STATE OF CONNECTICUT
CONNECTICUT SITING COUNCIL

APPLICATION OF SBA TOWERS III (SBA)
AND NEW CINGULAR WIRELESS PCS, LLC
(AT&T) FOR A CERTIFICATE OF
ENVIRONMENTAL COMPATIBILITY AND
PUBLIC NEED FOR THE CONSTRUCTION,
MAINTENANCE AND OPERATION OF A
TELECOMMUNICATIONS TOWER FACILITY
AT WEWAKA BROOK ROAD IN THE TOWN
OF BRIDGEWATER

DOCKET NO. 412

SBA TOWERS III ("SBA") AND NEW CINGULAR WIRELESS PCS, LLC ("AT&T")
RESPONSES TO SITING COUNCIL INTERROGATORIES
SET I

ATTACHMENT 1

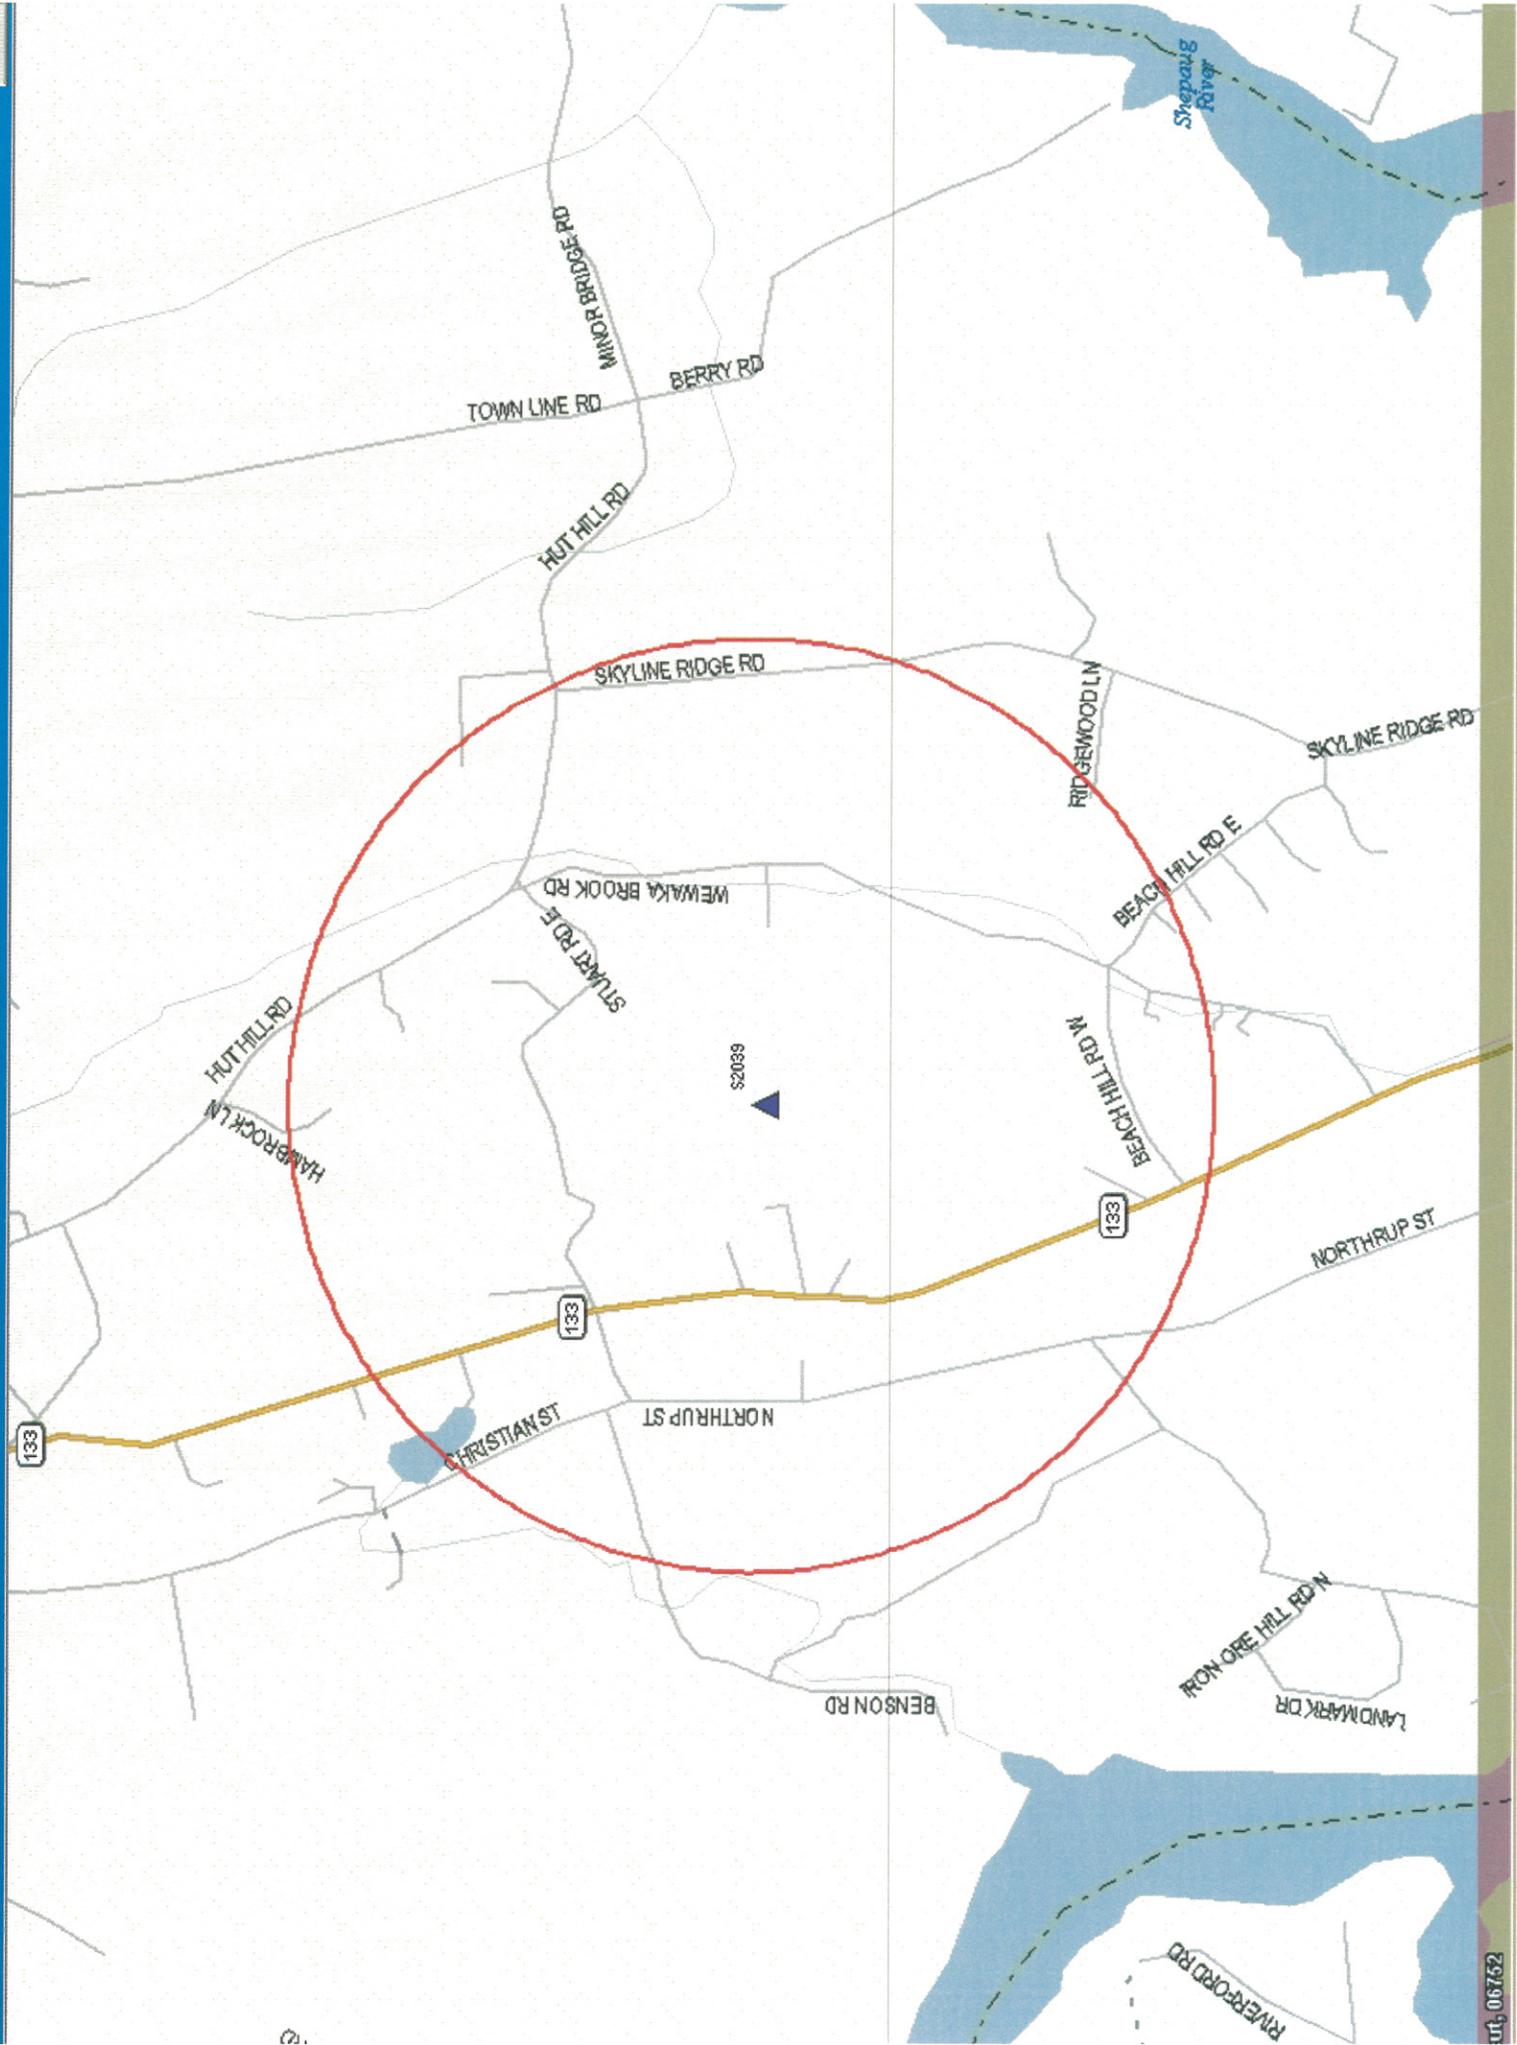
Q1. When was the search ring first initiated for a tower in this area? Provide the size, shape, and location of the center of the search ring.

A1. The search ring for this area has been in existence for several years. The search for a site is reflective of the overall area where siting options are limited. The site search is also indicative of AT&T's network over time which now includes an operational site in Newtown to the south. The map included in Attachment 1 is reflective of the site search area.

SR2039 Proposed Site
 Bridgewater, CT
 Lat: N 41-30-31.5
 Long: W 73-21-16.0
 Rad Center = 167 feet
 GE = 583' AMSL

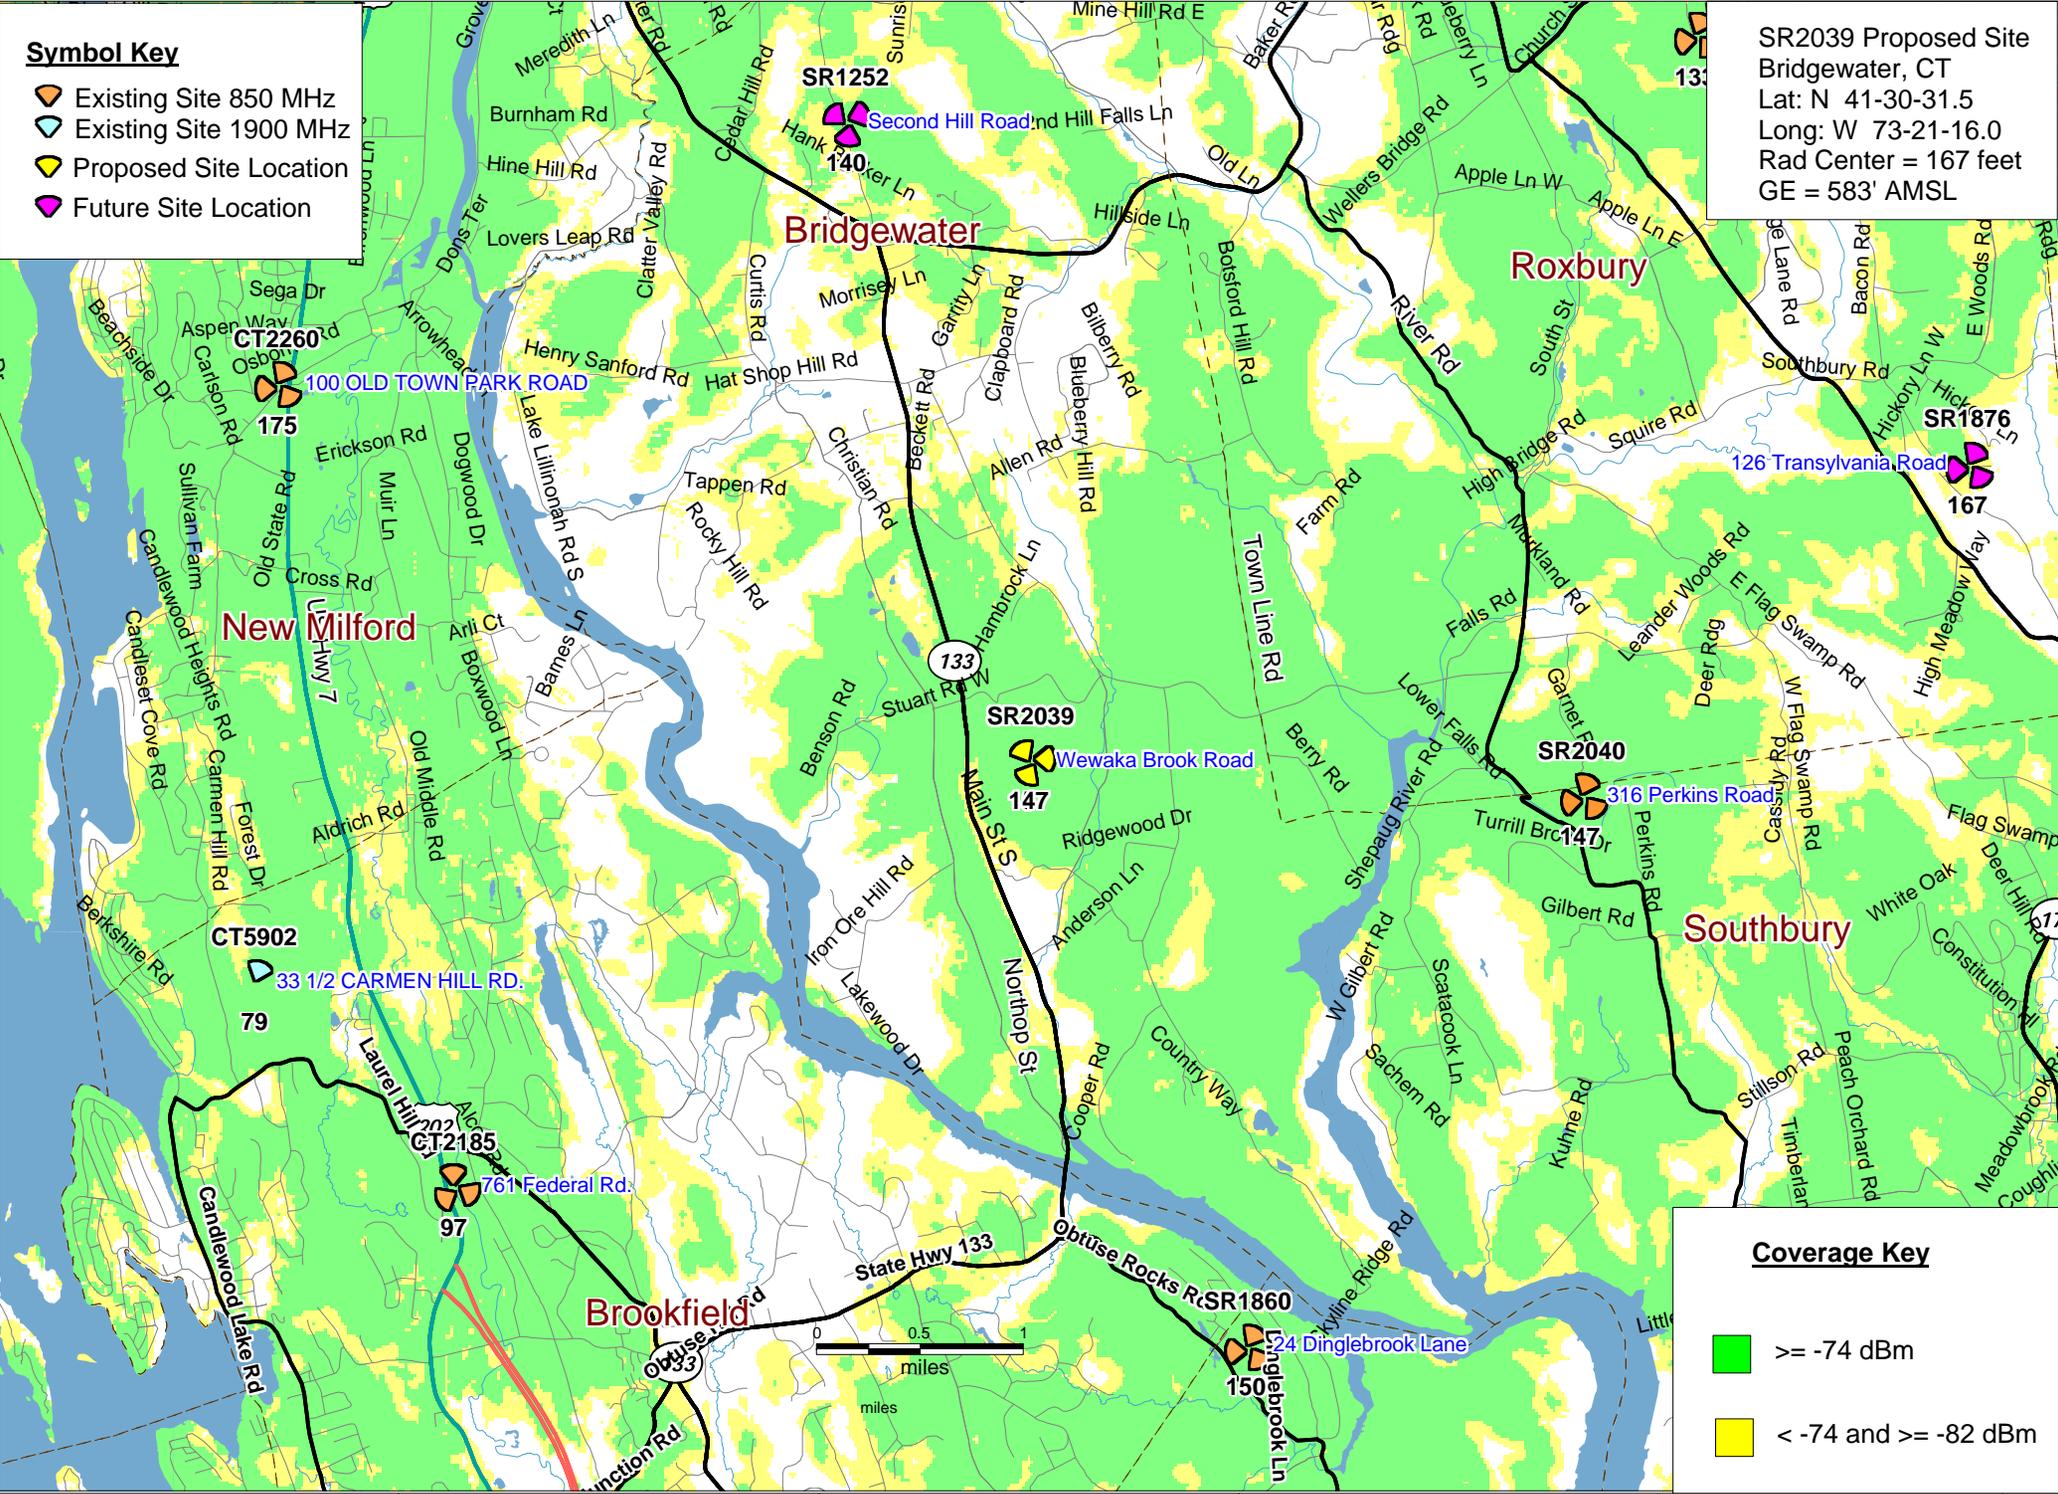
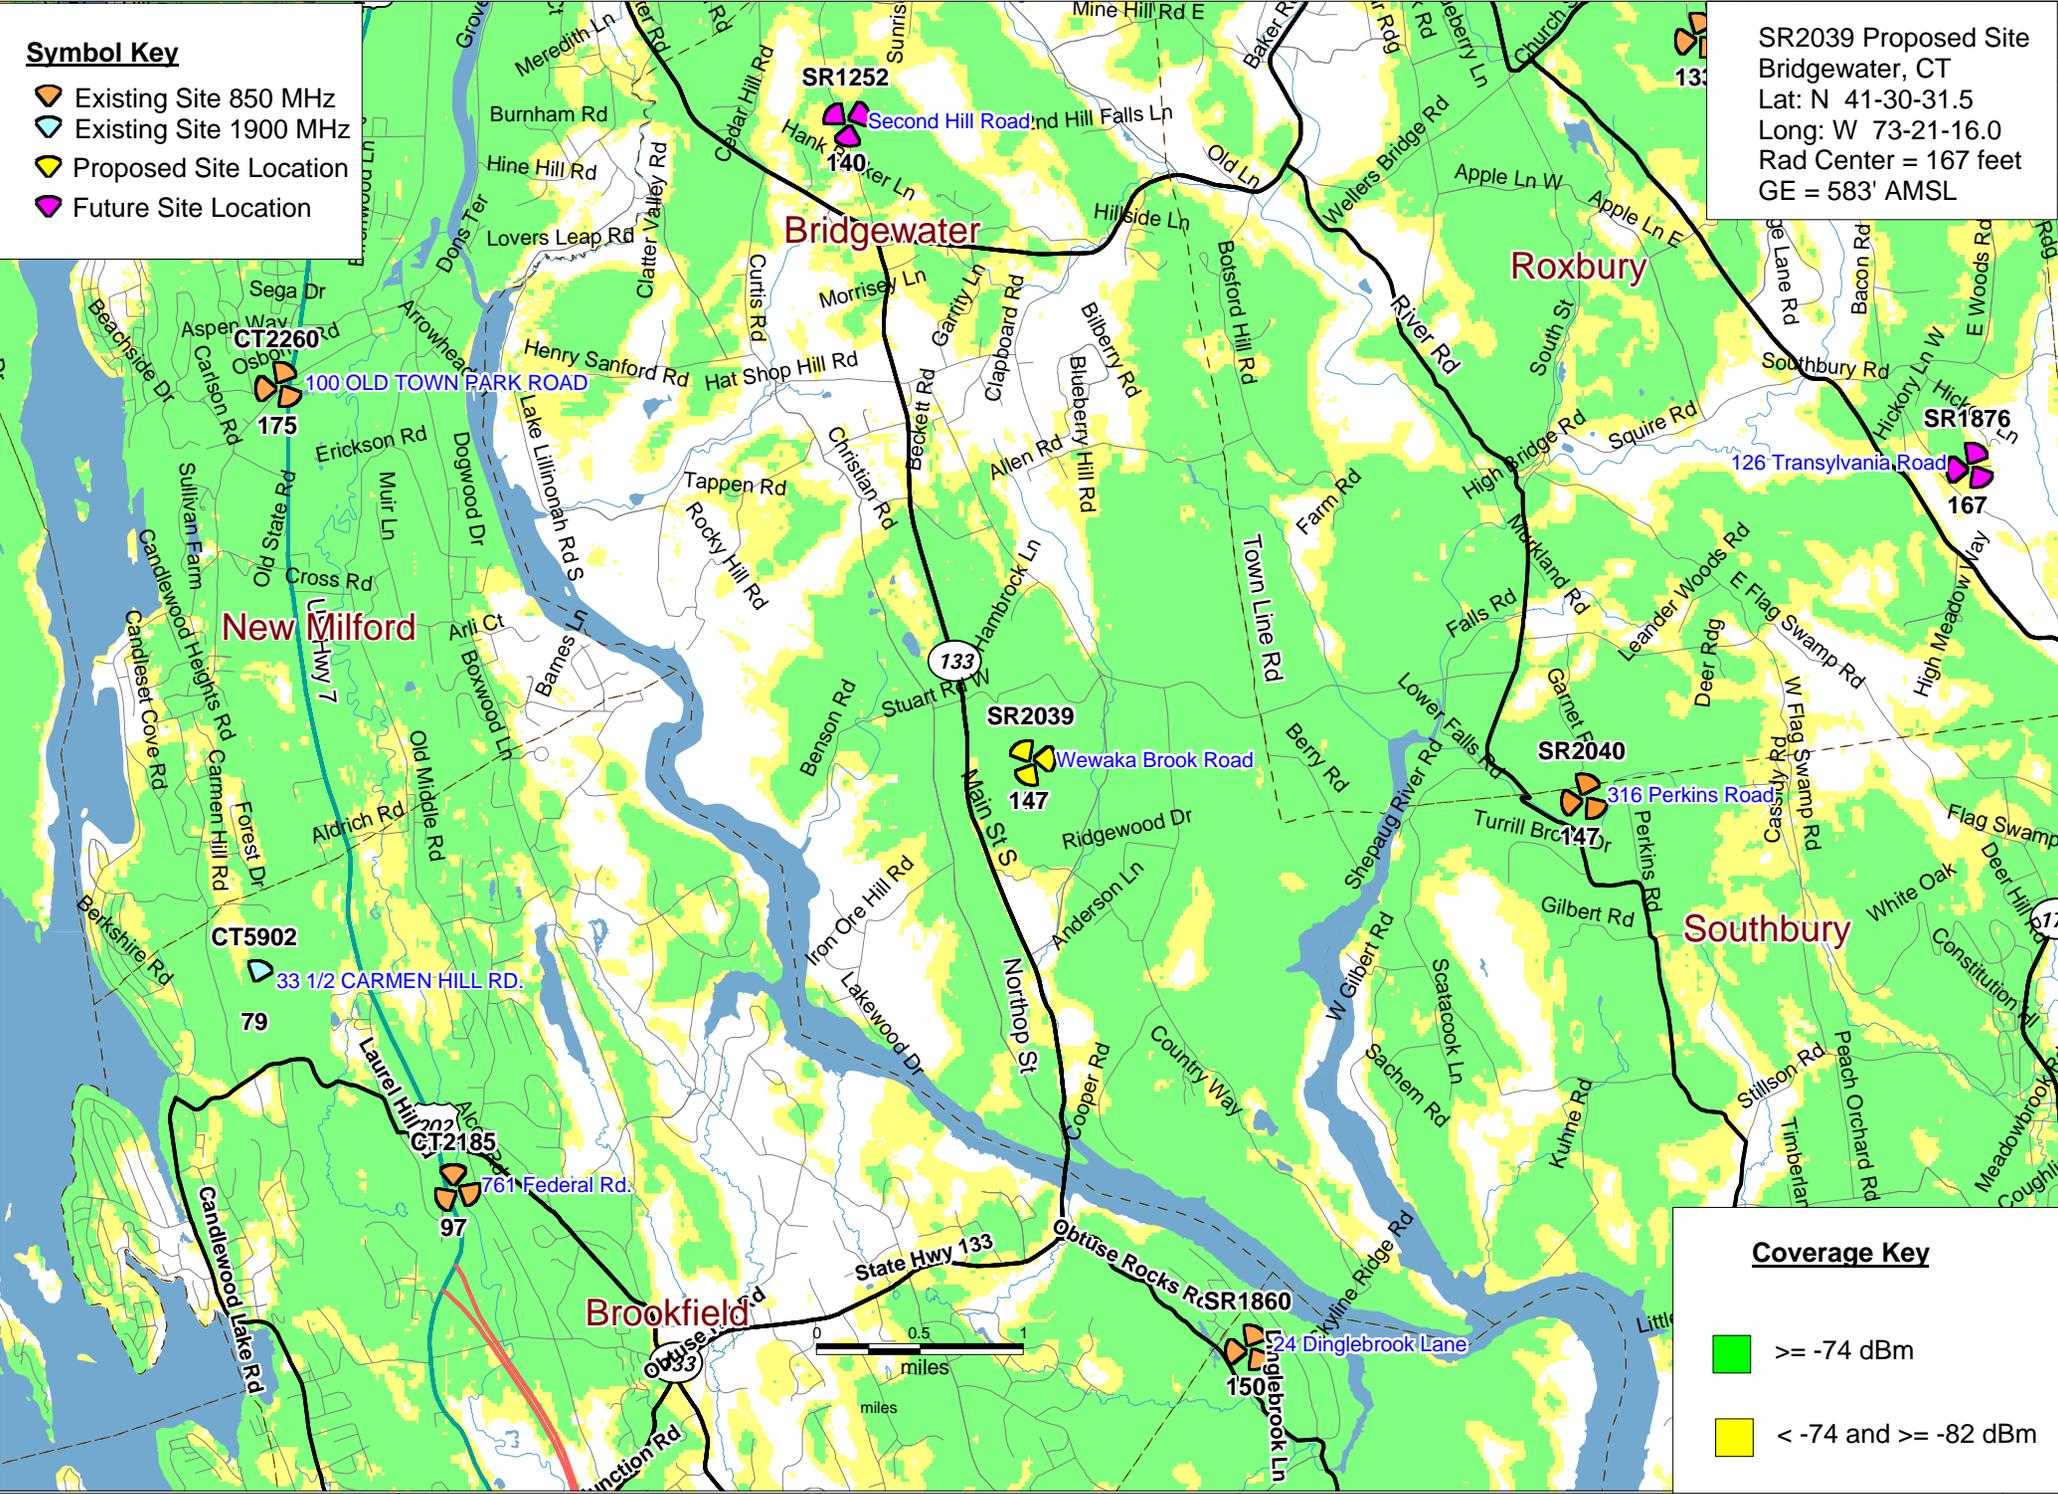
Q12. Provide coverage plots using the same scale provided assuming the tower is ten and twenty feet shorter, respectively.

A12. Enclosed in Attachment 4 are two propagation plots depicting existing coverage and proposed coverage from the proposed Facility at antenna centerline mounting heights of 157' and 147' AGL.
